PLANNING BOARD AGENDA FOR SEPTEMBER 22, 2026 - 7:00 PM

1. **Tuscan Village Master Development Site Plan** – Conceptual Discussion on revised master plan for Tuscan Village to include 120-key hotel, 392 apartments, 72 workforce housing units, medical office, general office, bank, and restaurant uses at 14-24 Tuscan Blvd, Map 107, Lot 12605. Continued from 7/28/2026.

TUSCAN VILLAGE MASTER PLAN UPDATE

SHEET: 4

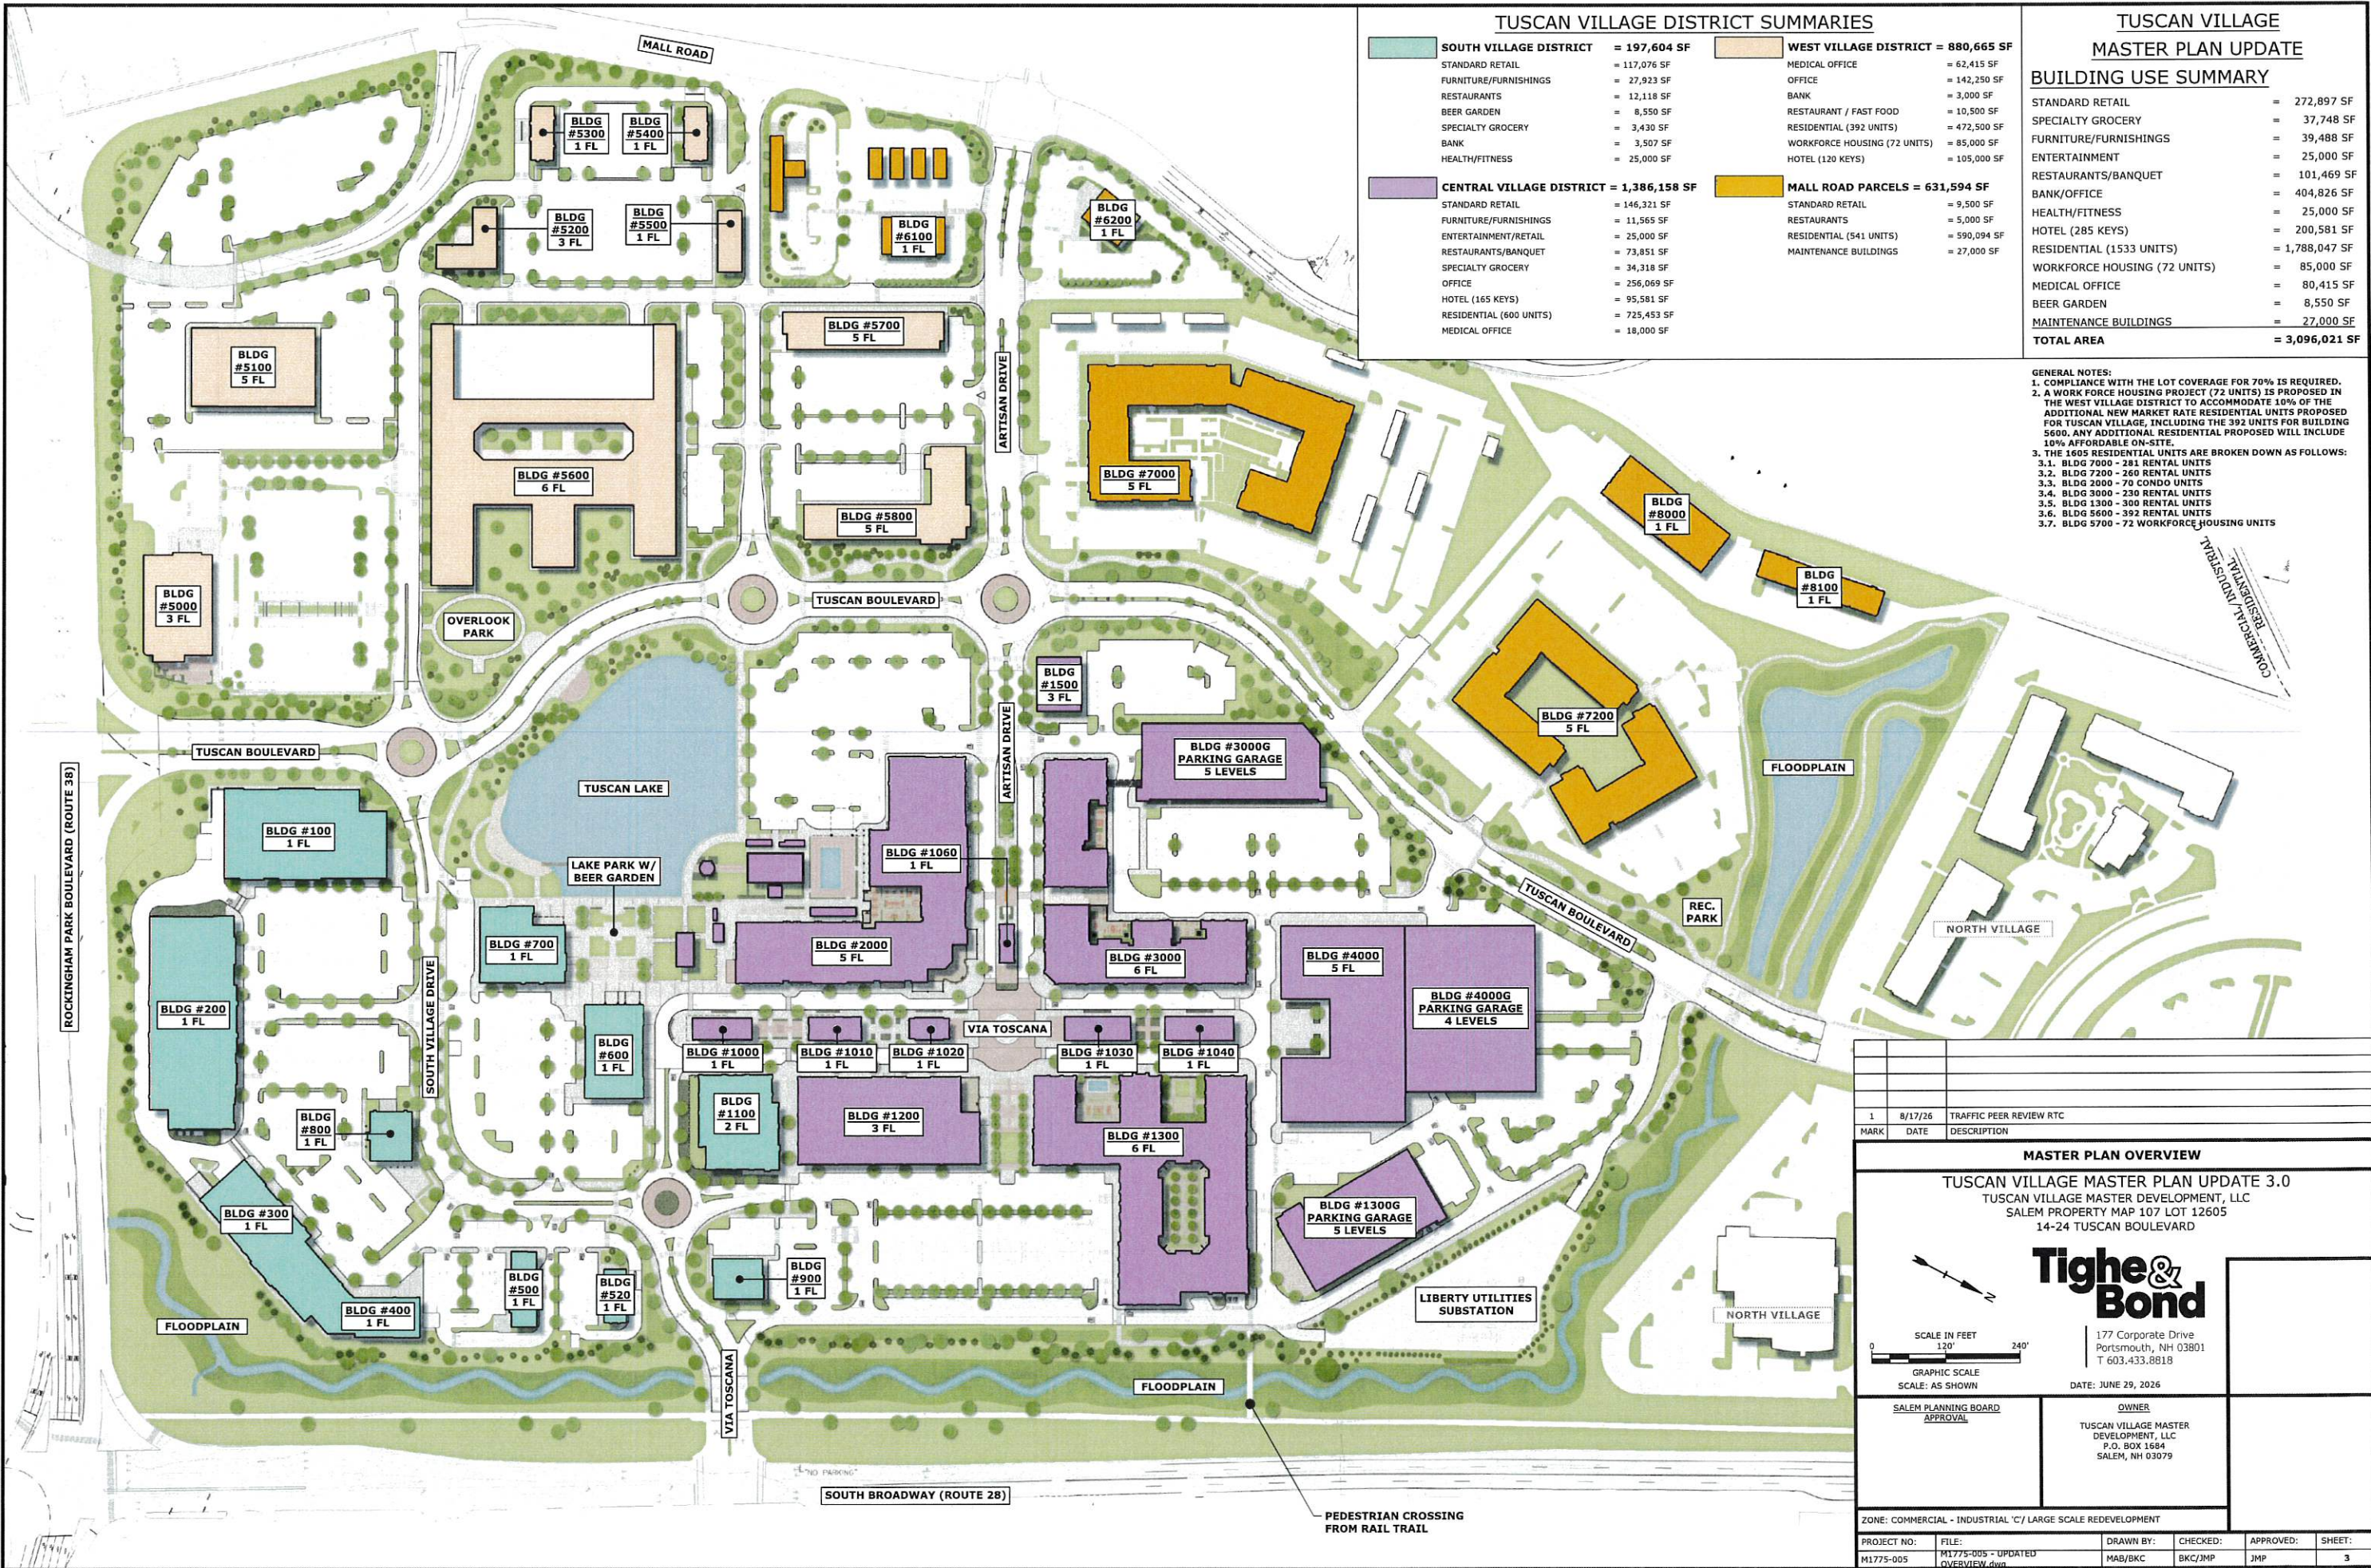
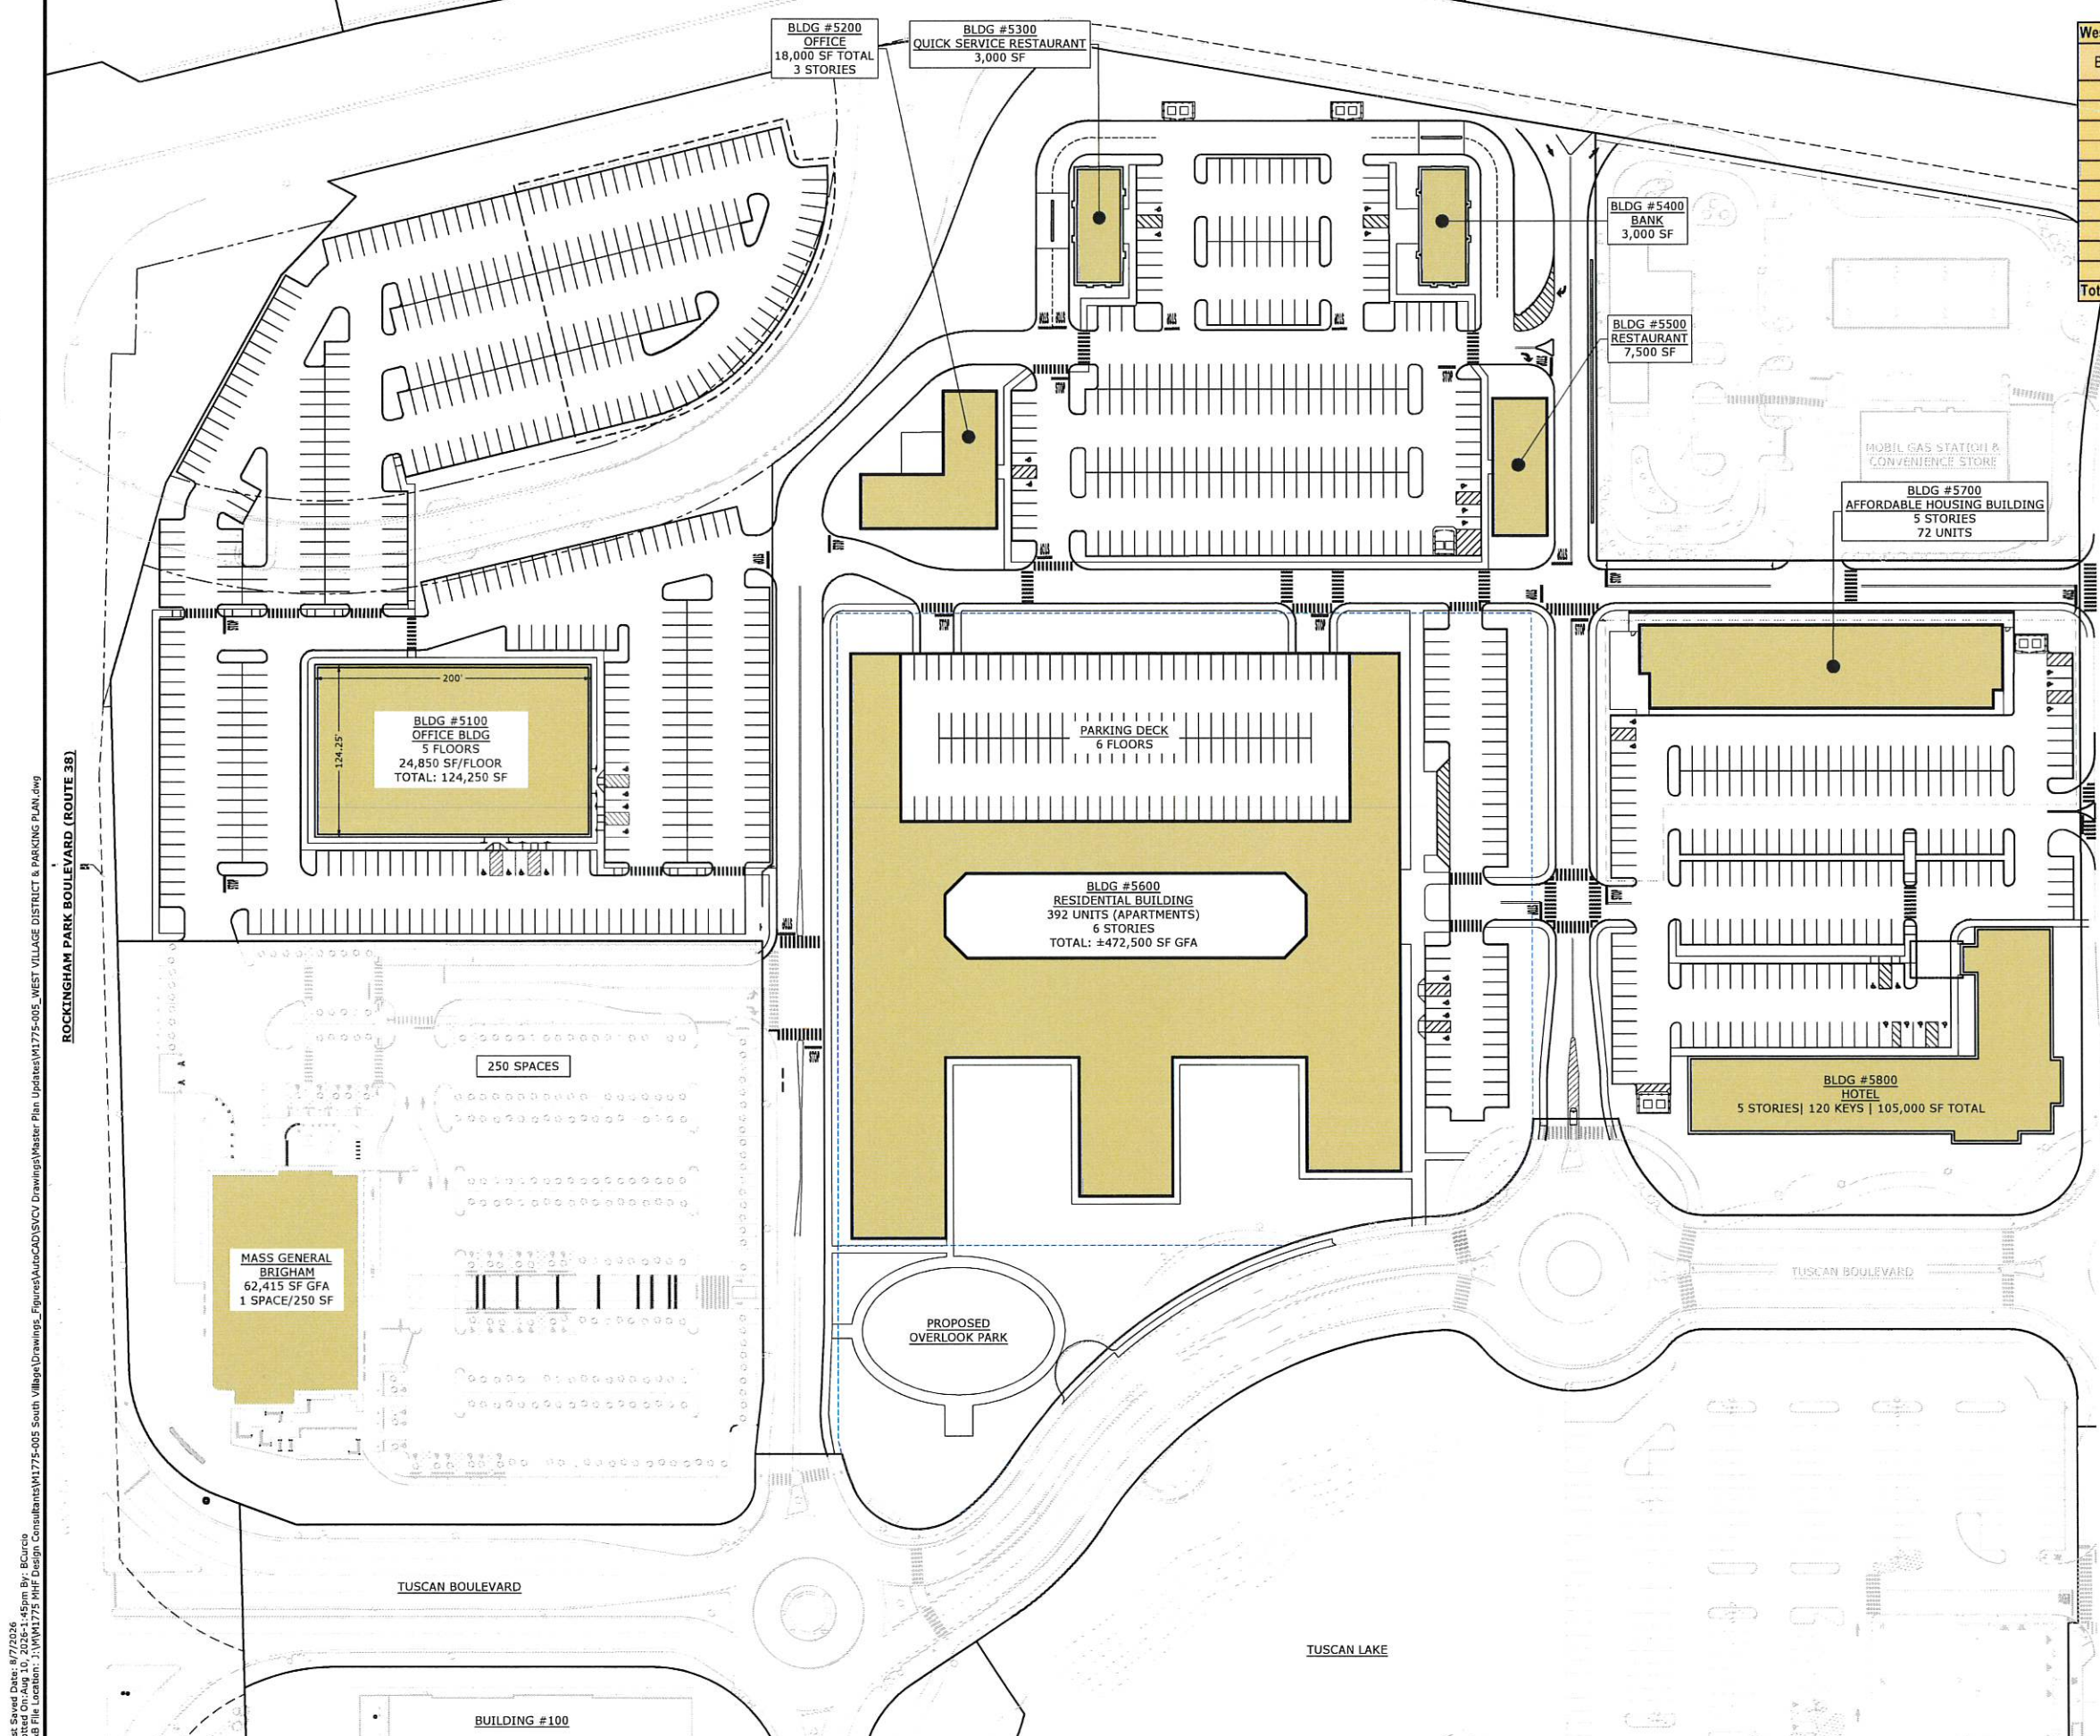
- Sheet 3 – Master Plan Overview
The total gfa for the Central Village District should be changed from 1,446,966 to 1,446,511 for the math to add up and to be consistent with Sheet 5.
- Sheet 4 – West Village District
The table in the upper right-hand corner is not consistent with the information on the plan view. The gfa for Building 5000 should be changed from 63,000 to 62,415 sf for consistency with Sheet 5.
- Sheet 6 – Parking Plan
The gfa for Building 5000 should be changed from 63,000 to 62,415 sf for consistency with Sheet 5.

Comment 25: *West Village District Plan - Sheet 4 includes an outdated table that reflects the old building program from the June 2025 design. The table should be updated to match the current plans and to match the table on Sheet 5.*

Response: All these sheets have been updated accordingly. The sf areas in some of the districts have been updated based on changes of use in those areas. (i.e in the South Village District the restaurant in B 800 is now retail). The listed Restaurant/Banquet space listed on Sheet 2 has been adjusted to 92,350 sf such that the sum of all uses equals 3,652,553. The values within District Summary and Building Use Summary tables on Sheet 3 have been revised to be consistent with the tables on Sheet 5 for all districts. The GFA shown within the footprint of Building 5000 on Sheet 4 has been adjusted to 62,415 sf. The GFA shown within the footprint of Building 5000 on Sheet 6 has been adjusted to 62,415 sf. See attached updated Sheets 2-7.

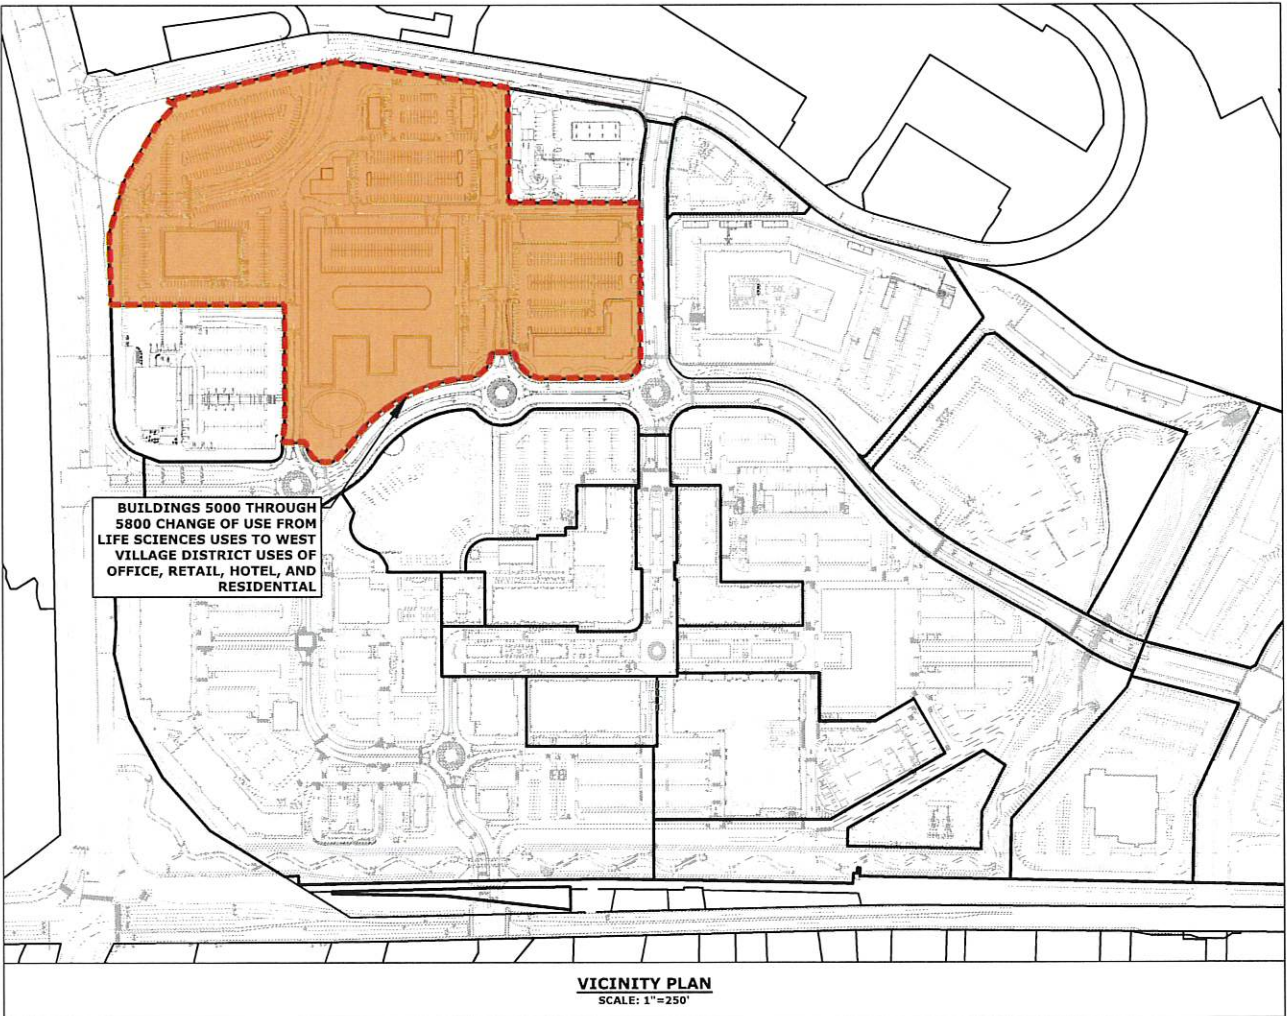
These buildings are considered South Village on the Change Of Use Tables/Plan (Sheet 5 of Master Plan Update 3.0), but due to their location, they are included in the Central Village LUC 820 Trip Gen calcs:
